CALL NO. 105
CONTRACT ID NO. 221042
ADDENDUM # 2

Subject: BREATHITT COUNTY, STP 0151(093)
Letting August 18, 2022

- (1) Revised - Special Note - Pages 17-41 of 122 (Omit Page 42)
- (2) Revised - Utility Note - Pages 83-85 of 122
- (3) Revised - Proposal Bid Items - Pages 121-122 of 122
- (4) Revised - Plan Sheets - R2, R2A, G02, G03, and G04

KY Highway 15 – Panbowl Lake Dam (Item # 10-172.00)

KY 15 (PANBOWL LAKE)
TYPICAL SECTION SHEET
SHEET PILE CUTOFF WALL

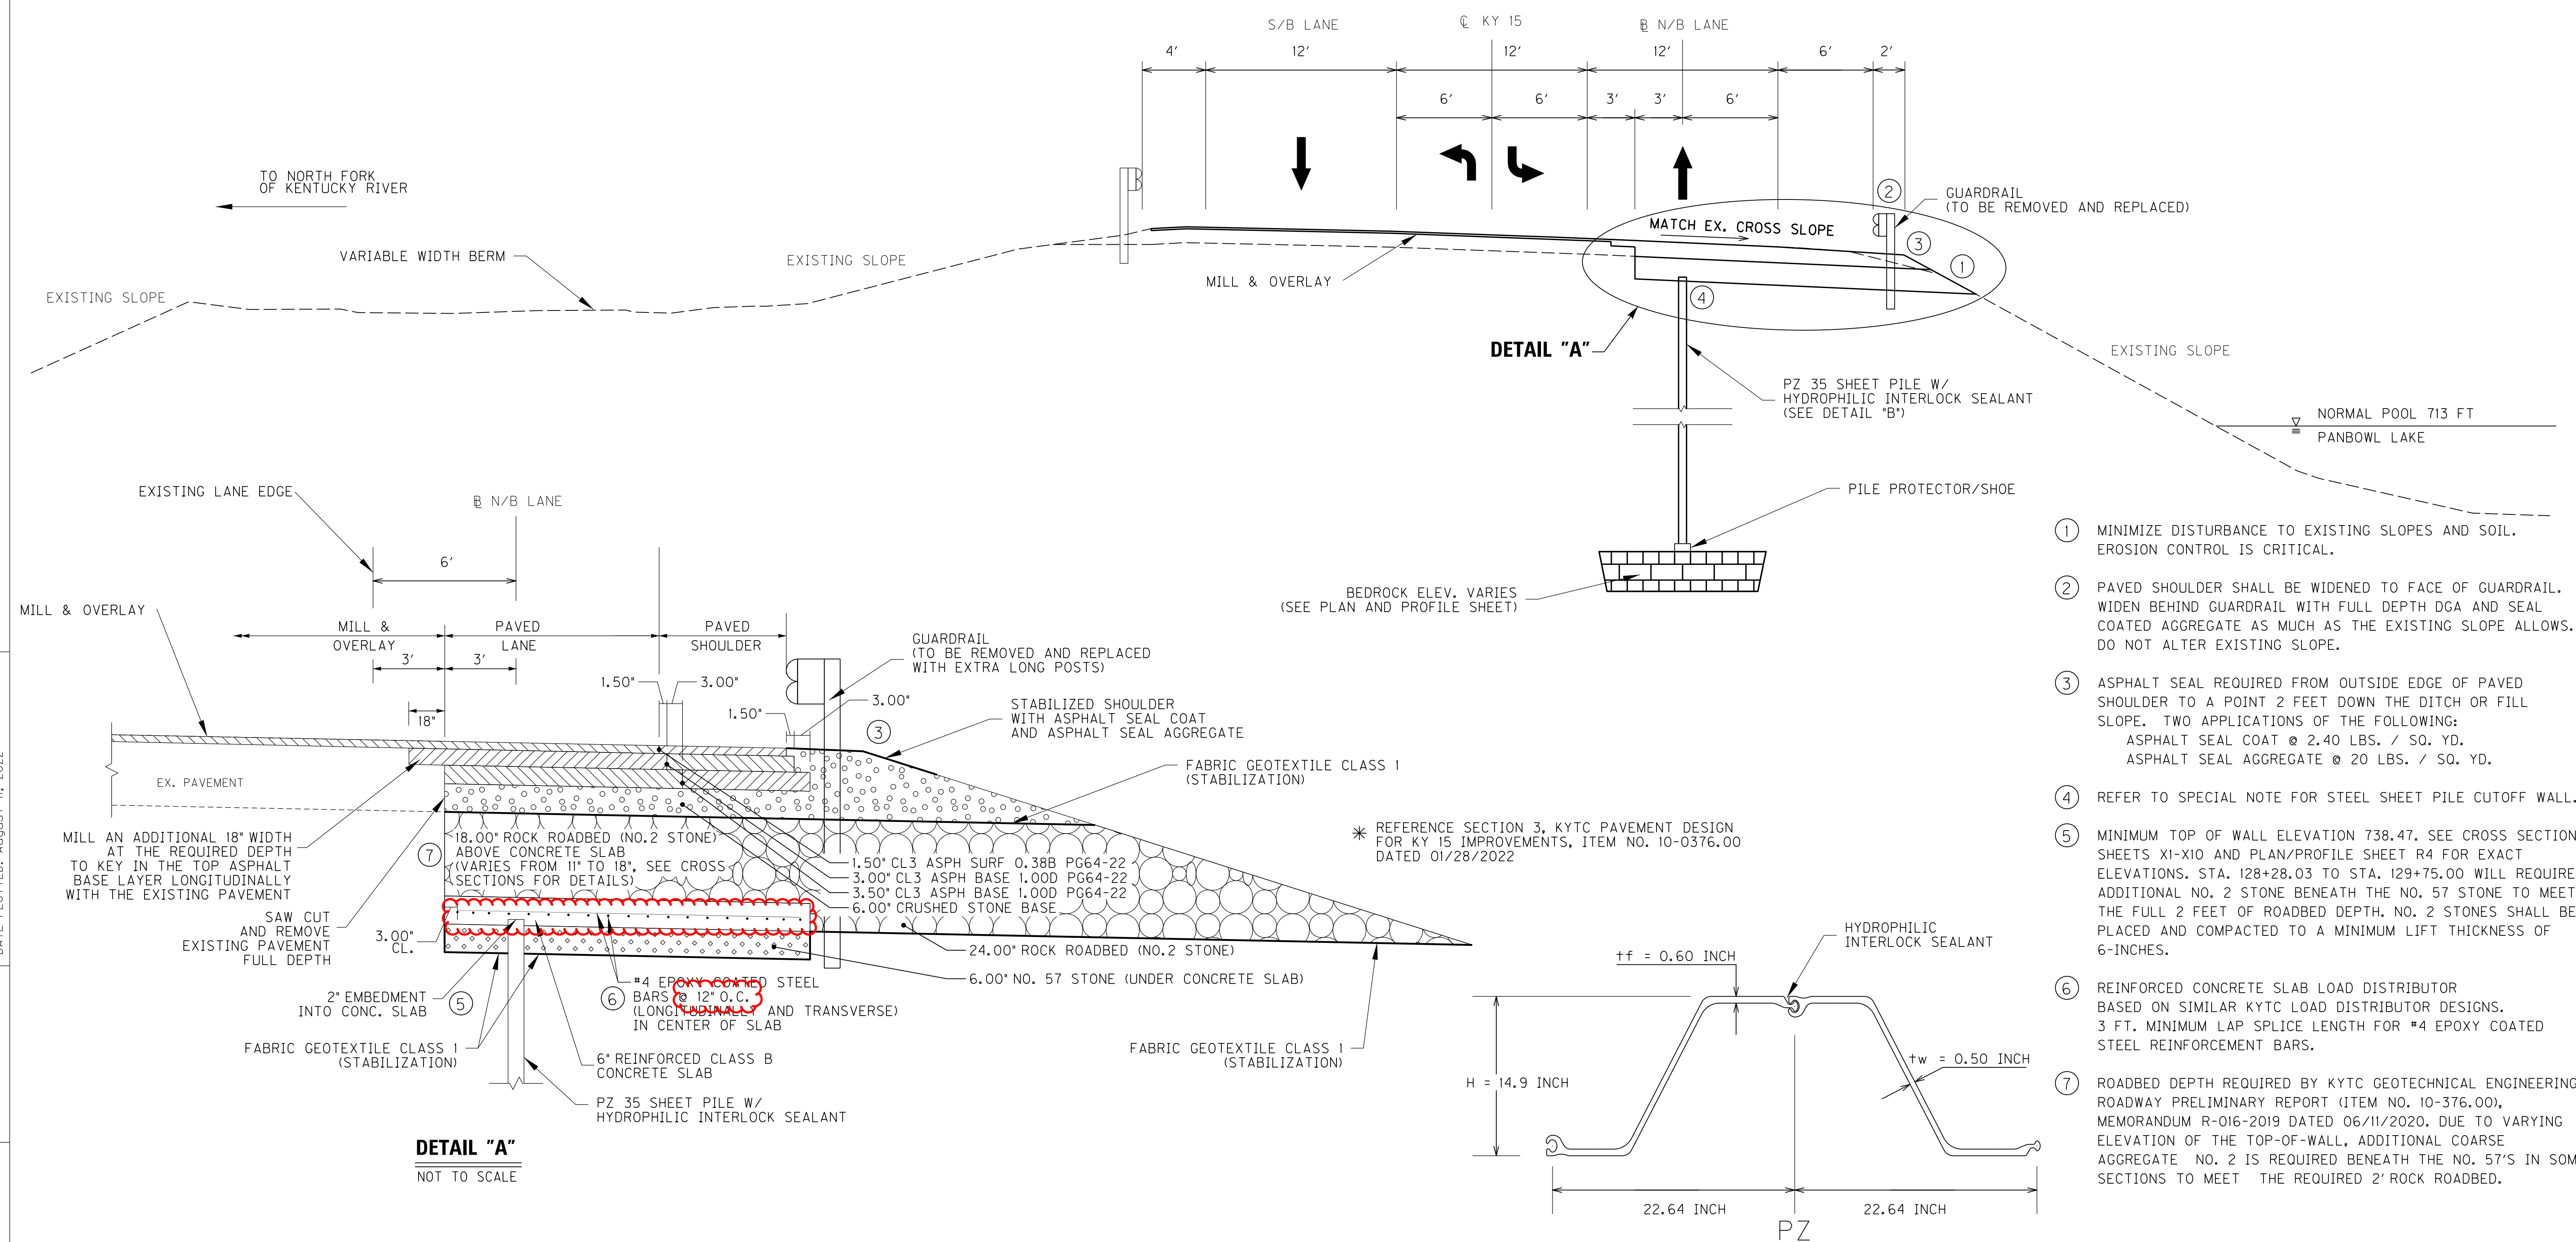
- ④ REFER TO SPECIAL NOTE FOR STEEL SHEET PILE CUTOFF WALL.
- ⑤ MINIMUM TOP OF WALL ELEVATION 738.47. SEE CROSS SECTION SHEETS XI-X10 AND PLAN/PROFILE SHEET R4 FOR EXACT ELEVATIONS. STA. 128+28.03 TO STA. 129+75.00 WILL REQUIRE ADDITIONAL NO. 2 STONE BENEATH THE NO. 57 STONE TO MEET THE FULL 2 FEET OF ROADBED DEPTH. NO. 2 STONES SHALL BE PLACED AND COMPACTED TO A MINIMUM LIFT THICKNESS OF 6-INCHES.

KY 15 (PANBOWL LAKE)
 SOIL PROFILE STA 123+00 TO STA. 127+00
 SHEET PILE CUTOFF WALL

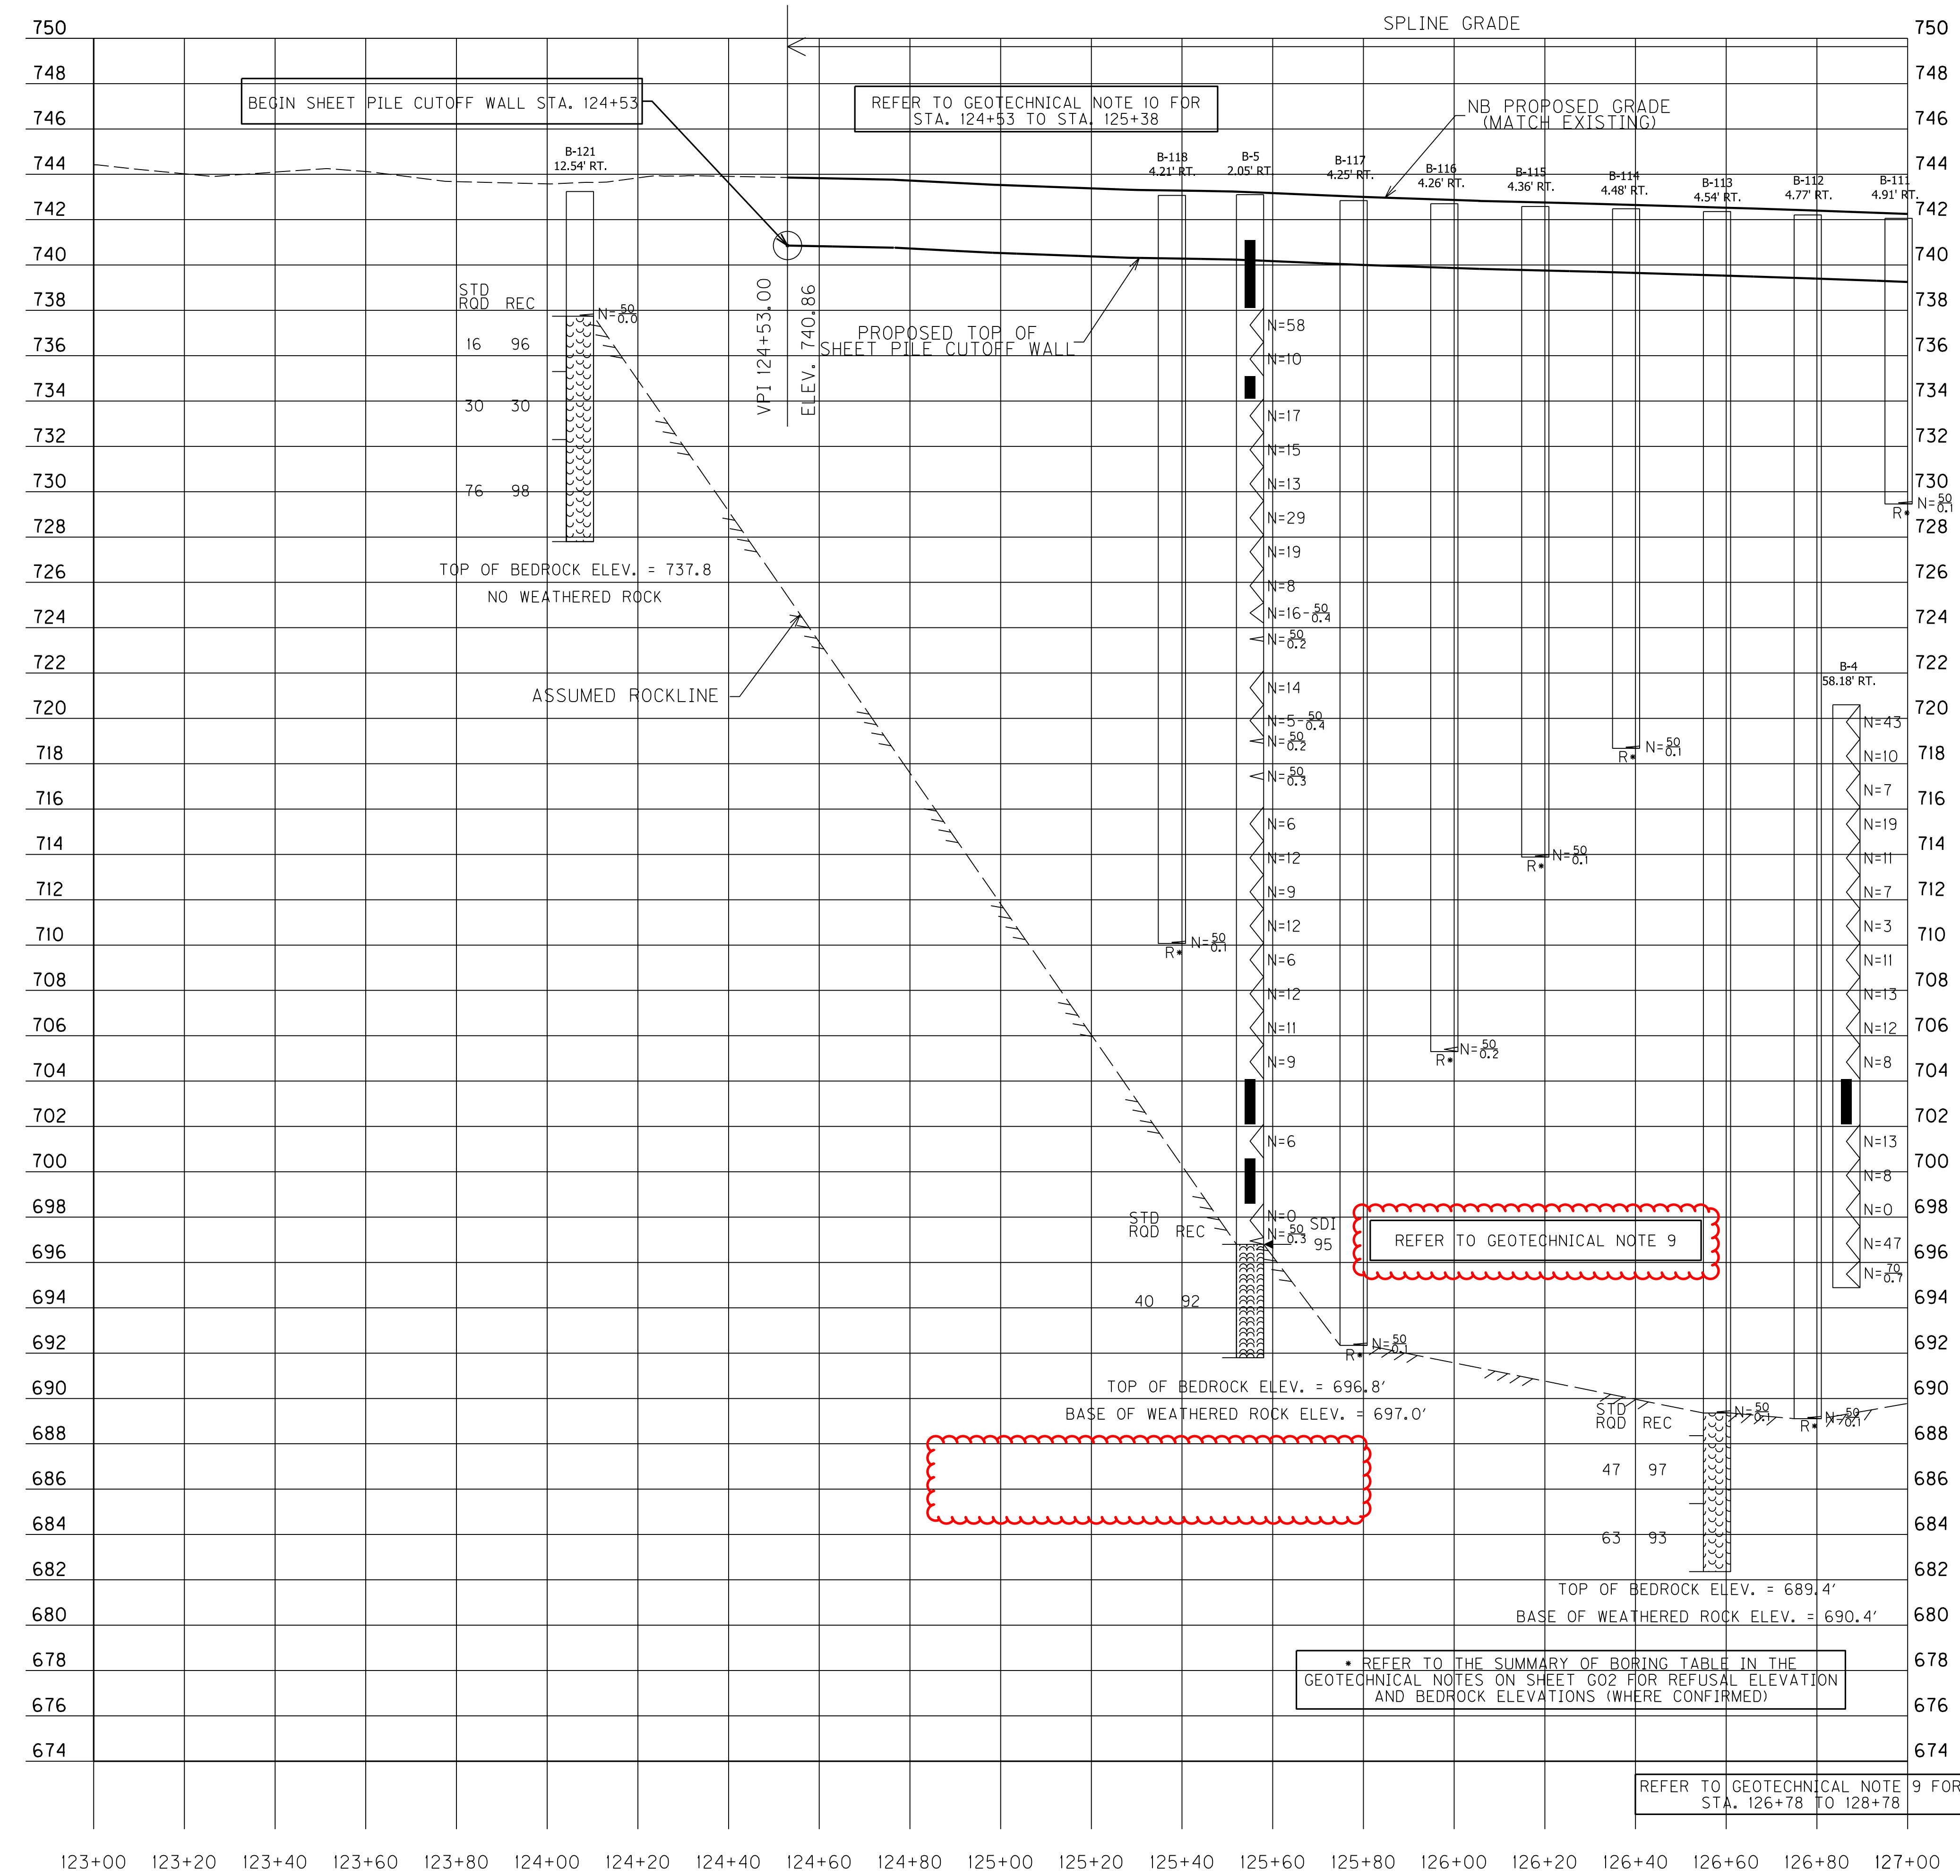
REVISED 08-11-2022

REFER TO GEOTECHNICAL NOTE 9

REFER TO THE SUMMARY OF BORING TABLE IN THE GEOTECHNICAL NOTES ON SHEET G02 FOR REFUSAL ELEVATION AND BEDROCK ELEVATIONS (WHERE CONFIRMED)

KY 15 (PANBOWL LAKE)
 SOIL PROFILE STA. 127+00 TO STA. 131+00
 SHEET PILE CUTOFF WALL

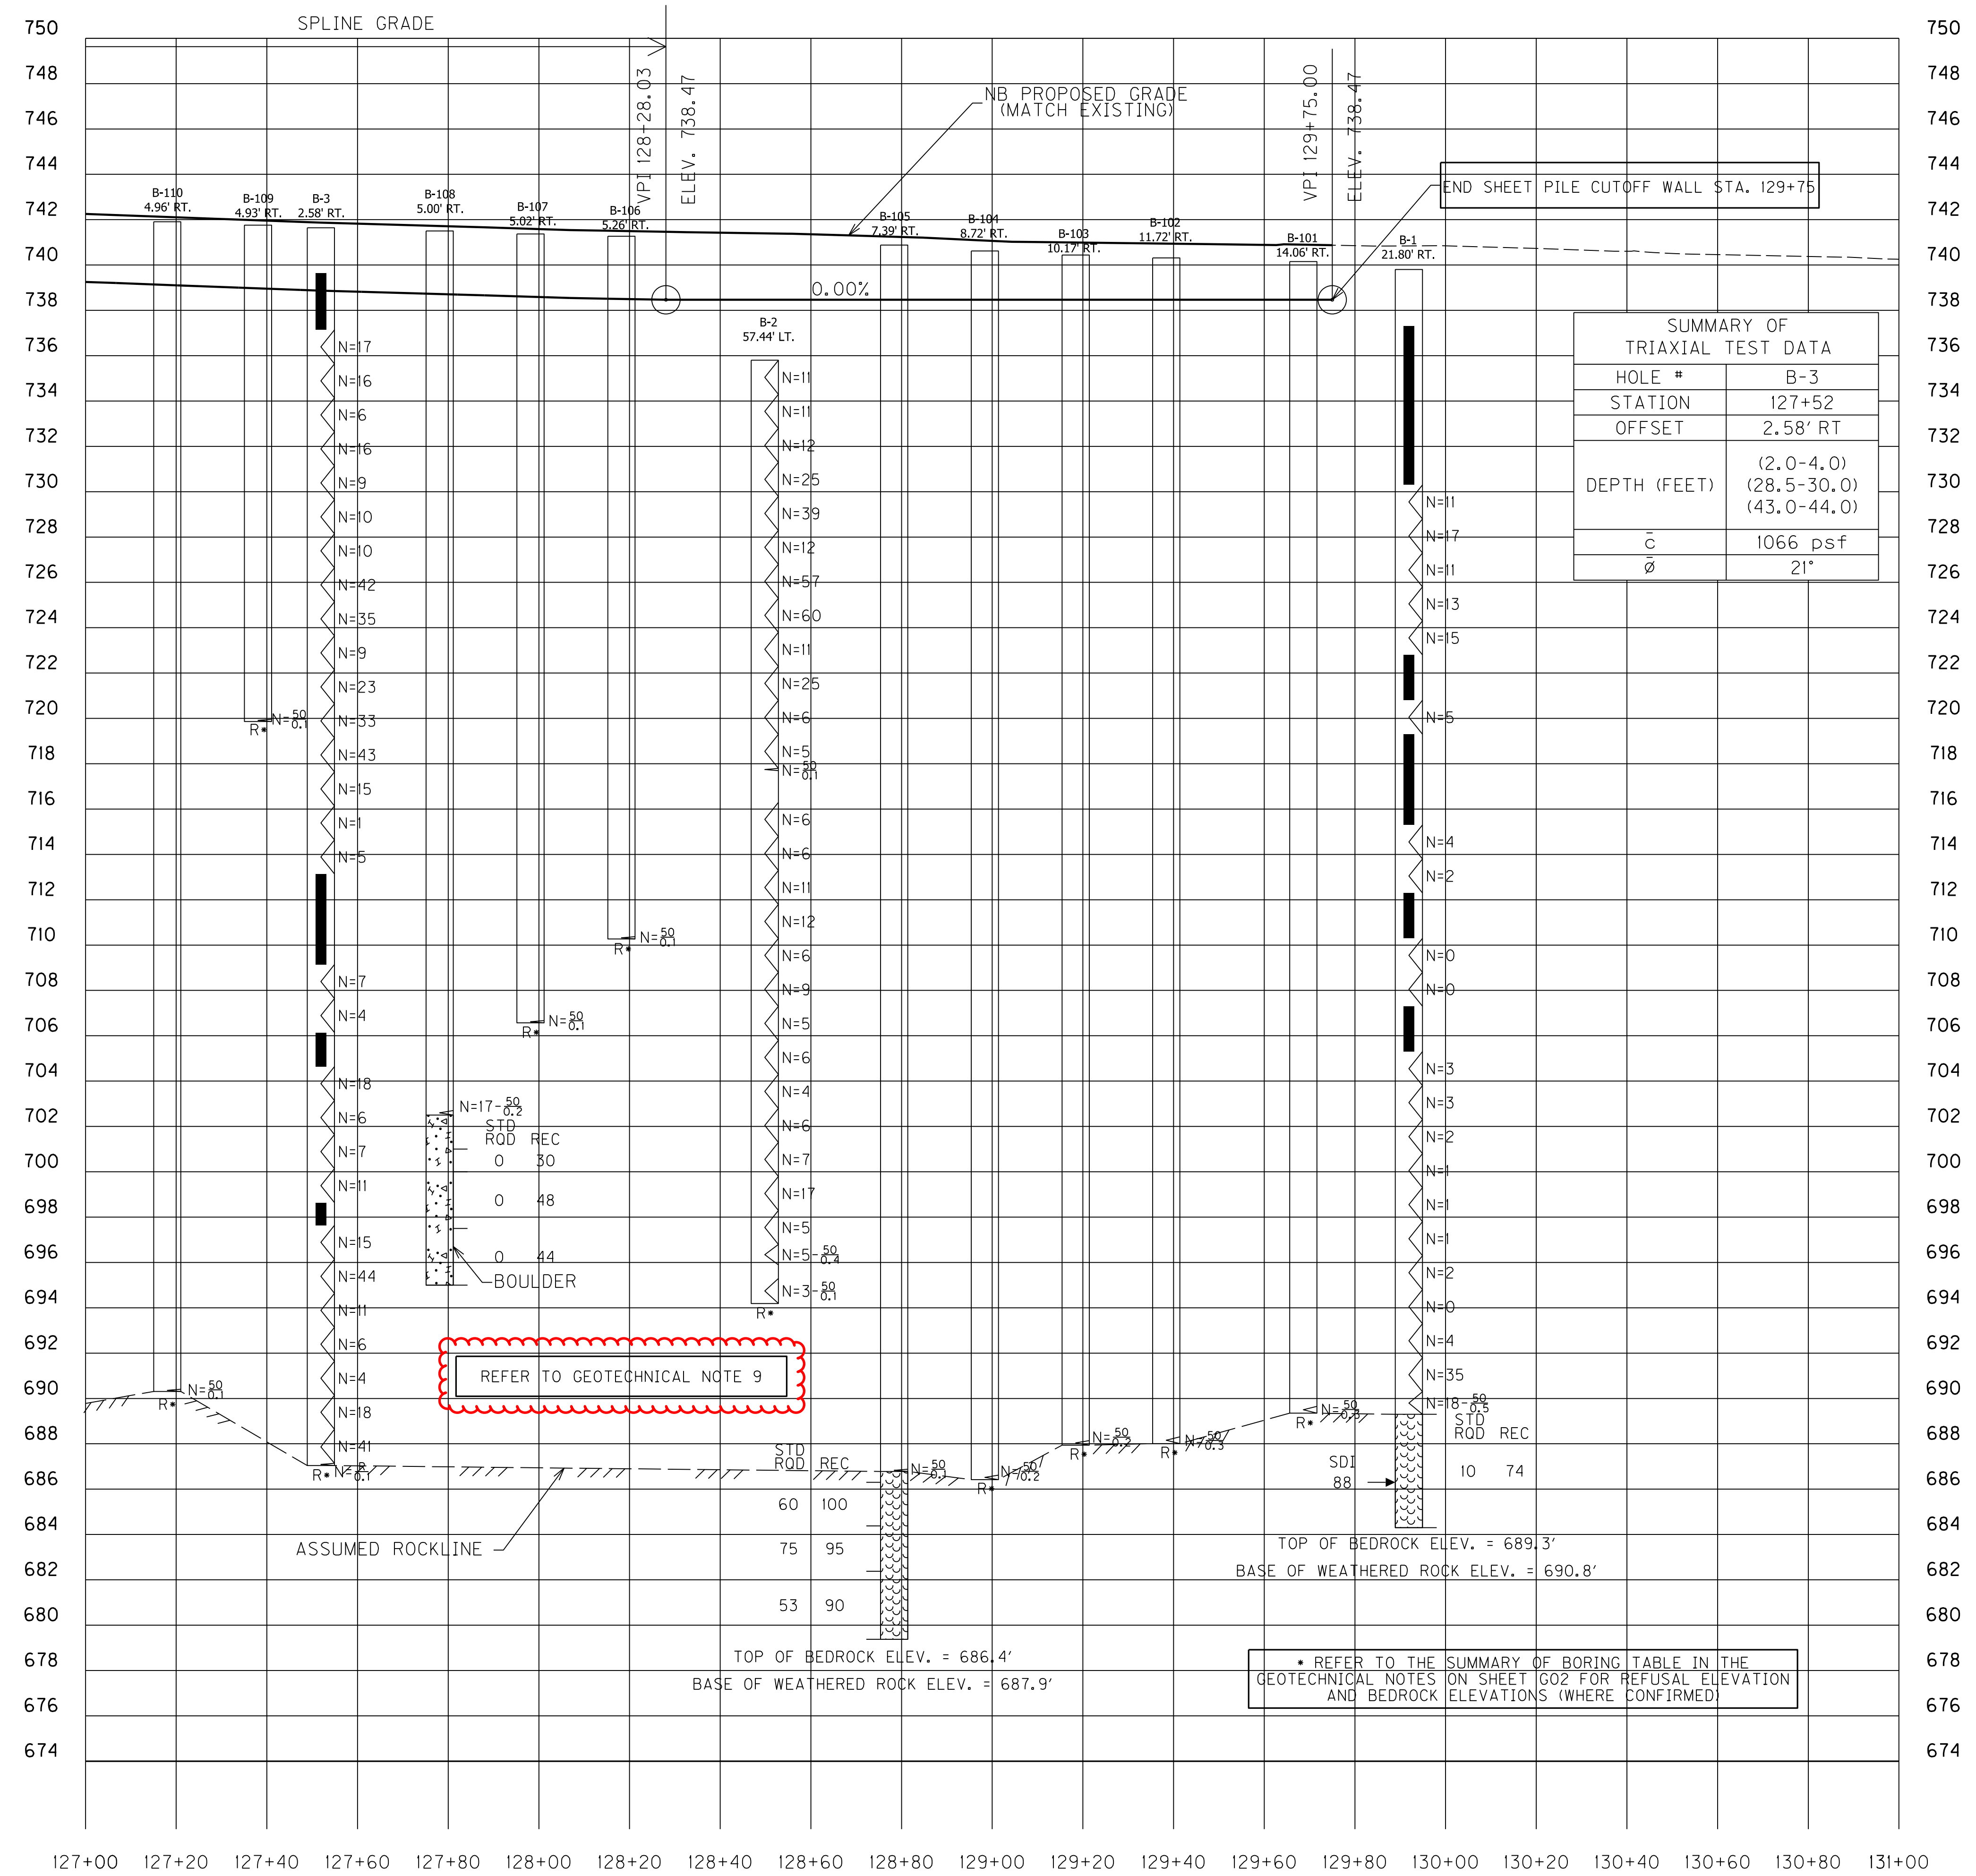
REVISED 08-11-2022
